Wisconsin Department of Transportation

Proposal #03: 3300-01-73, WISC 2018 137
C Lake Mills, Main Street
Topel Street to Madison Street
STH 89
Jefferson County

This is Addendum No. 01, which provides for the following:

ADDENDUM NO. 01

Addendum No. 01
ID 3300-01-73
Revised Sheet 88
February 26, 2018

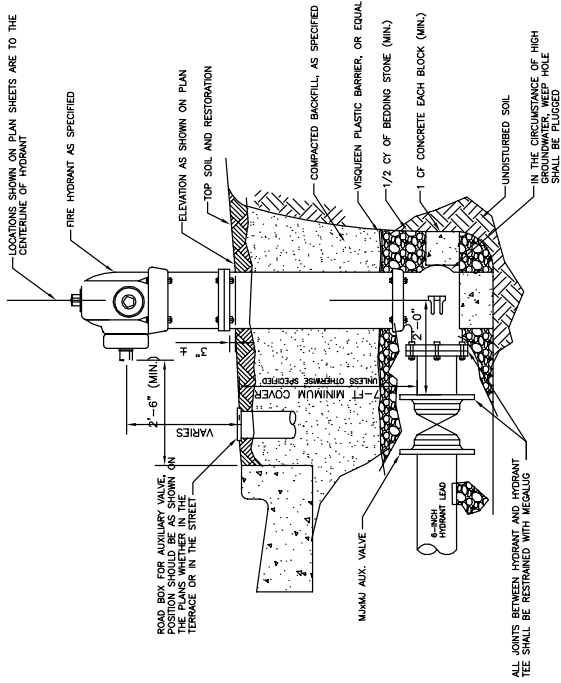
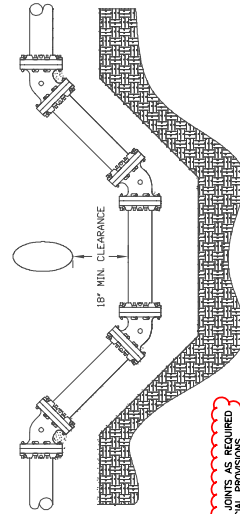
Revised Plan Sheets	
Plan Sheet	Plan Sheet Title (brief description of changes to sheet)
2	General Notes (Updated contact information for WE Energies and added Contact information for WisDNR for water line utility)
88	Water Main Details (Revised note regarding joint restraining)
89	Water Service and insulation Details (Revised notes regarding insulation thickness)
120	Permanent Signing & Marking (Add push button signs and adjusted pole location)
125	Permanent Signing & Marking (Add Ped. Crossing signs, arrows and push button signs. Revise location of Bike lane sign and pole.)
127	Lighting Plan General Notes (Updated notes to reflect change from using RRFB to Pedestrian Activated Beacons)
132	Lighting Plan Layouts (Revised beacon information at Milton Street to reflect changes from using RRFBs to Pedestrian Activated Beacons)
137	Lighting Plan Layouts (Revised beacon information at Water Street to reflect changes from using RRFBs to Pedestrian Activated Beacons)

Addendum No. 01
ID 3300-01-73
Revised Sheet 132
February 26, 2018

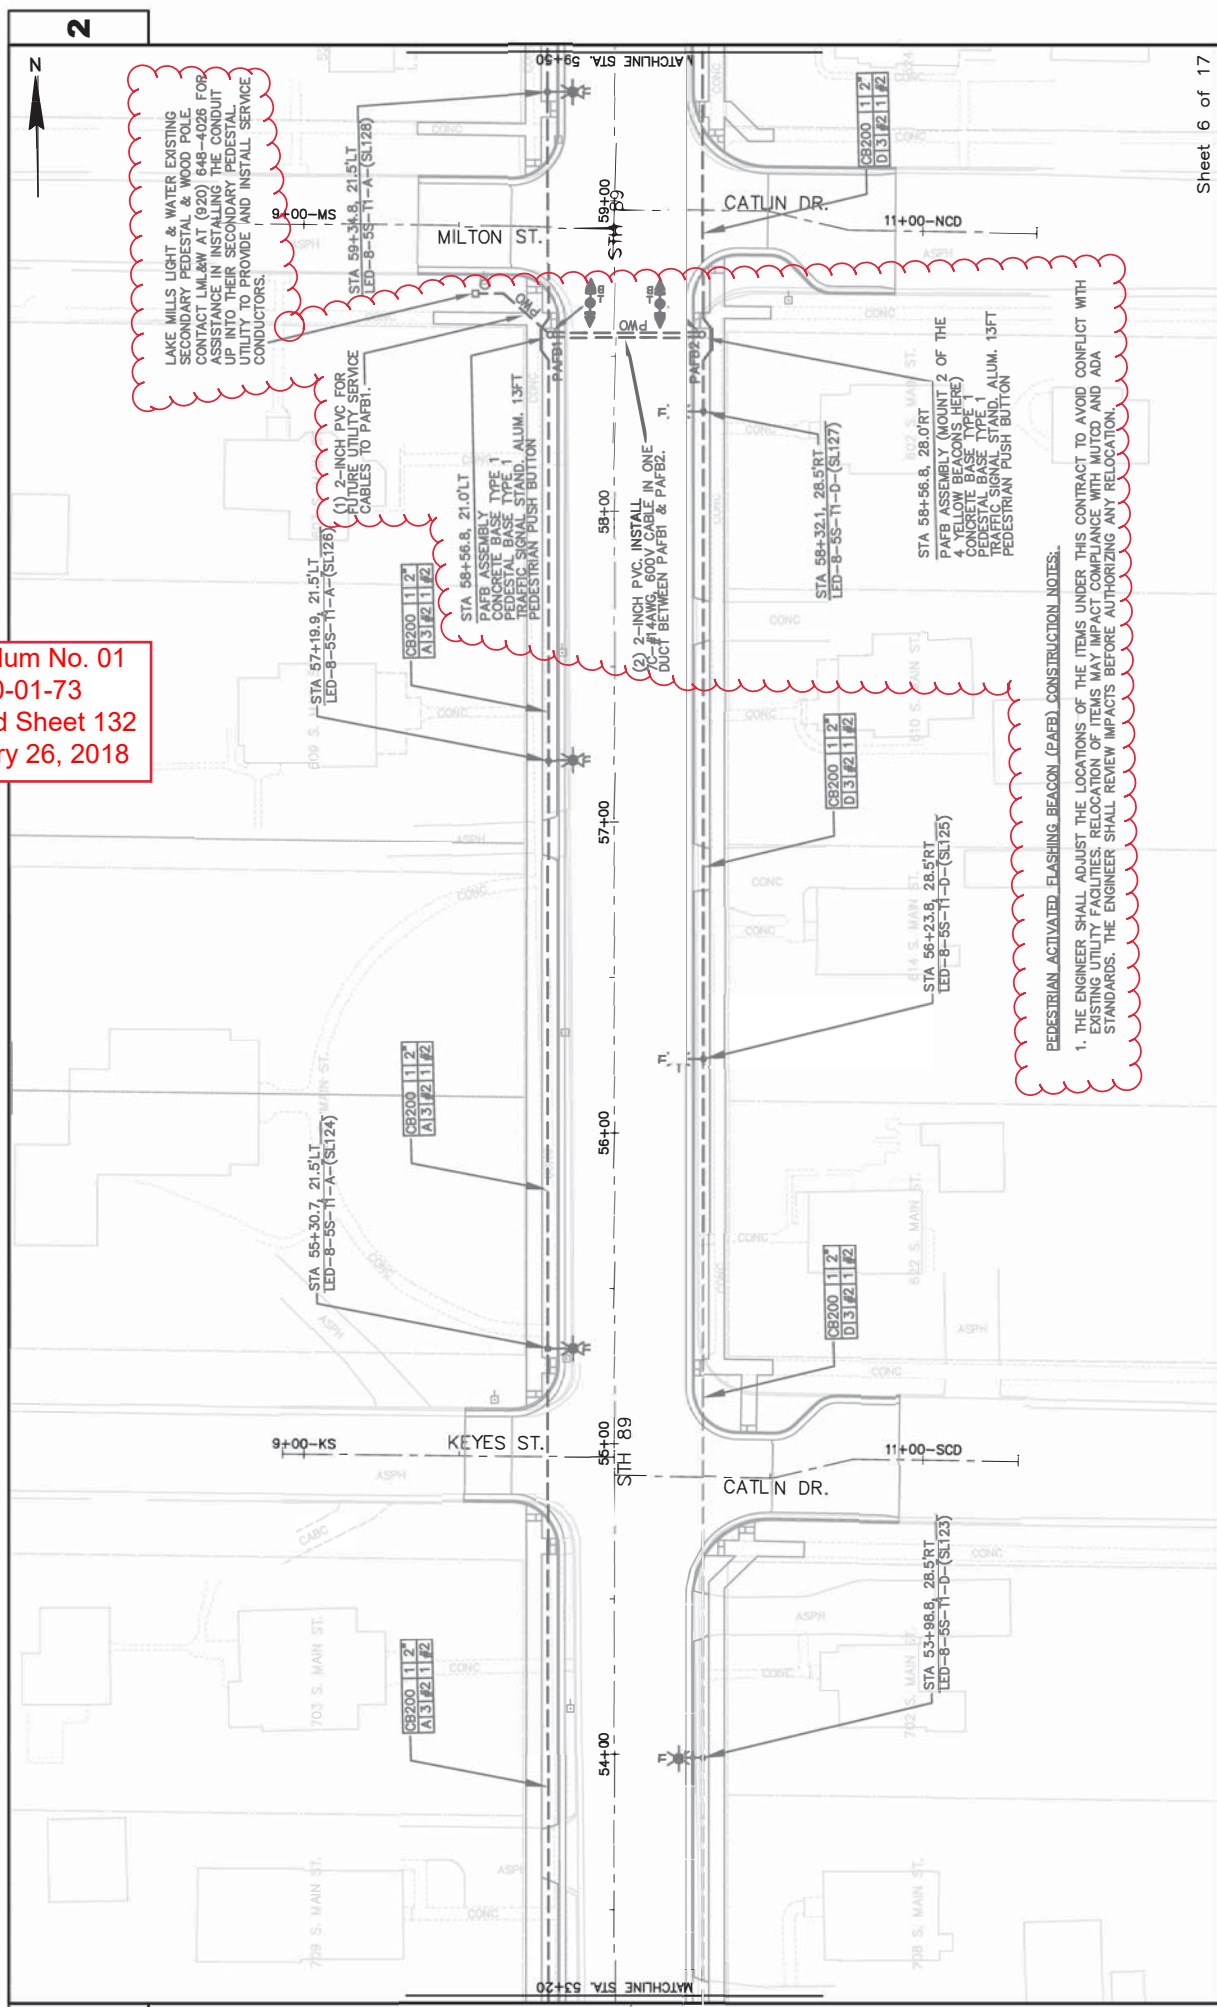
PEDESTRIAN ACTIVATED FLASHING BEACON (PAFB) CONSTRUCTION NOTES:

(1) 2-INCH PVC FOR FUTURE UTILITY SERVICE CABLES TO PAFB1.

(2) 2-INCH PVC, INSTALL 600V CABLE IN ONE DUCT BETWEEN PAFB1 & PAFB2.

STA 56+56.8, 28.0'RT
PAFB ASSEMBLY (MOUNT 2 OF THE 4 YELLOW BEACONS HERE)
CONCRETE BASE TYPE 1 TRAFFIC SIGNAL STAND, ALUM. 13FT PEDESTRIAN PUSH BUTTON

Addendum No. 01
 ID 3300-01-73
 Revised Sheet 137
 February 26, 2018

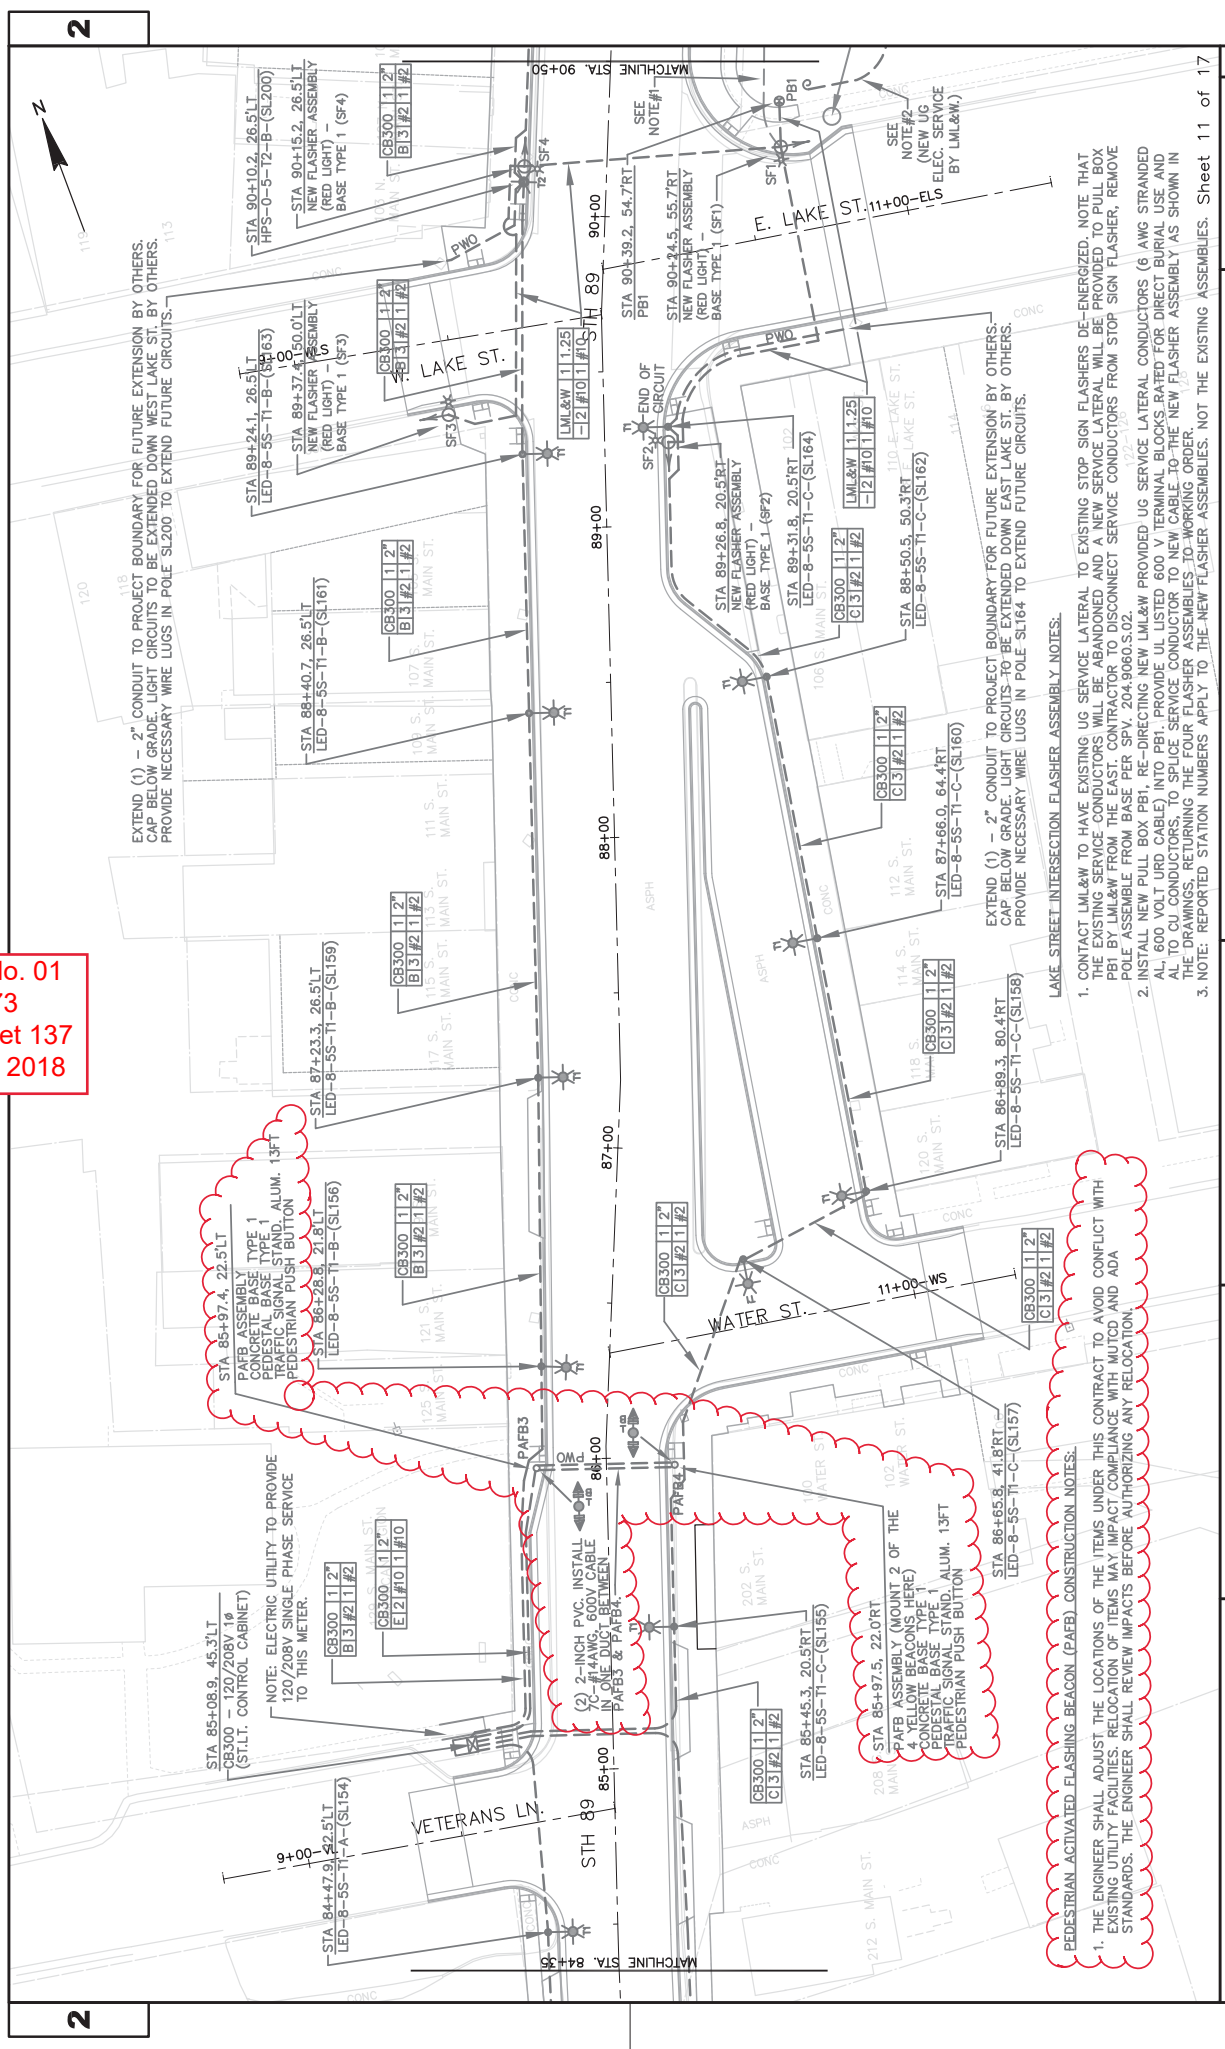
LAKE STREET INTERSECTION FLASHER ASSEMBLY NOTES:

- CONTACT LML&W TO HAVE EXISTING UG SERVICE LATERAL TO EXISTING STOP SIGN FLASHERS DE-ENERGIZED. NOTE THAT THE EXISTING SERVICE CONDUCTORS WILL BE ABANDONED AND A NEW SERVICE LATERAL WILL BE PROVIDED TO PULL BOX PBI BY LML&W FROM THE EAST. CONTRACTOR TO DISCONNECT SERVICE CONDUCTORS FROM STOP SIGN FLASHER. REMOVE POLE ASSEMBLY FROM BASE PER SITE: 204-9060.502.
- INSTALL NEW PULL BOX PBI, RE-DIRECTING NEW LML&W PROVIDED UG SERVICE LATERAL CONDUCTORS (6 AWG STRANDED ALUMINUM) TO PBI. RE-DIRECTING EXISTING UG SERVICE CONDUCTORS TO NEW PBI. REMOVE EXISTING PBI AND ALL TO CU CONDUCTORS TO STOP SIGN FLASHER ASSEMBLY. THE NEW FLASHER ASSEMBLY (AS SHOWN IN THE DRAWINGS) RETURNING THE FOUR FLASHER ASSEMBLIES TO WORKING ORDER.
- NOTE: REPORTED STATION NUMBERS APPLY TO THE NEW FLASHER ASSEMBLIES. NOT THE EXISTING ASSEMBLIES. Sheet 11 of 17

STA 85+97.4, 22.5LT
 PAFB ASSEMBLY
 CONCRETE BASE TYPE 1
 PEDESTRIAN SIGNAL STAND, ALUM. 13FT
 PEDESTRIAN PUSH BUTTON
 LED-8-55-TI-B-(SL156)

STA 85+97.5, 22.0RT
 PAFB ASSEMBLY (MOUNT 2 OF THE 4 YELLOW BEACONS HERE)
 CONCRETE BASE TYPE 1
 PEDESTRIAN SIGNAL STAND, ALUM. 13FT
 PEDESTRIAN PUSH BUTTON
 LED-8-55-TI-C-(SL155)

Addendum No. 01
ID 3300-01-73
Added Sheet 337A
February 26, 2018

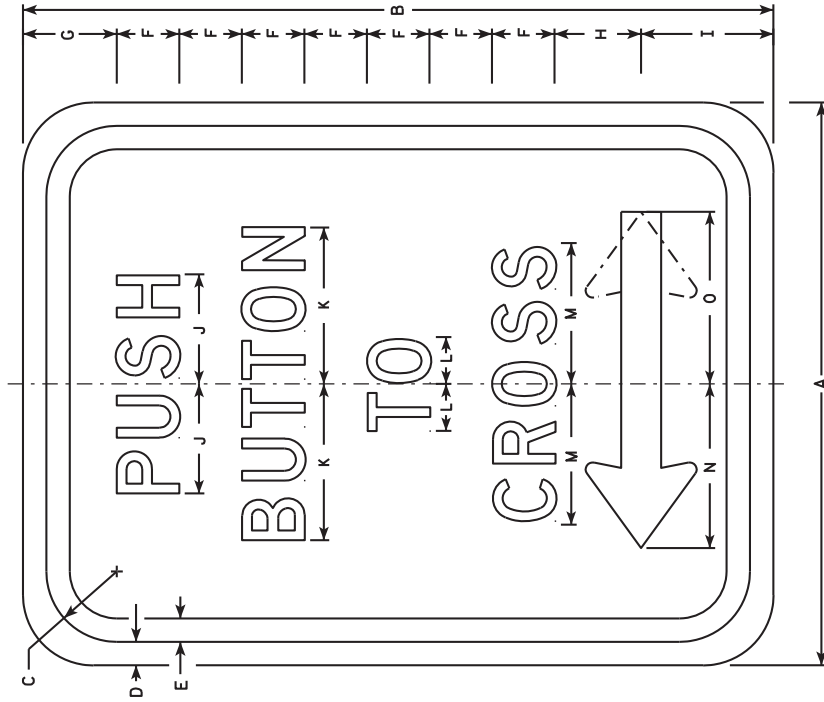
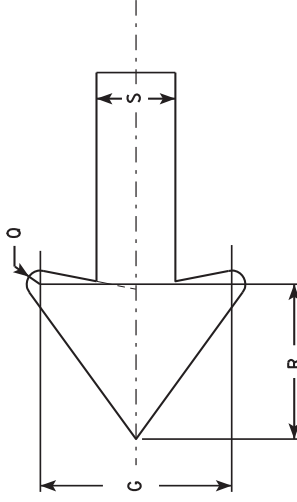
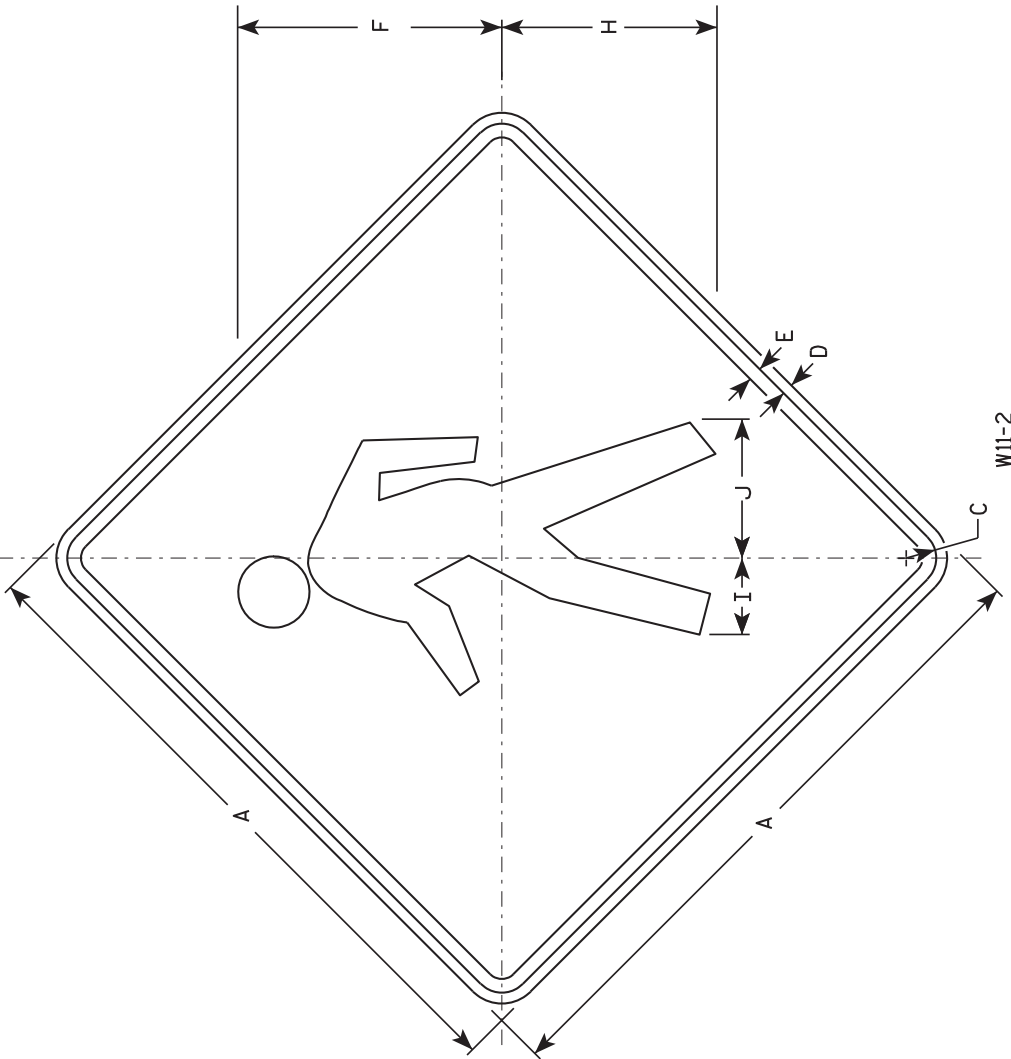
Added Plan Sheets	
Plan Sheet	Plan Sheet Title (brief description of why sheet was added)
337A	Sign Plate – Added sign RR10-4D, L & R
347A	Sign Plate – Added sign W11-2
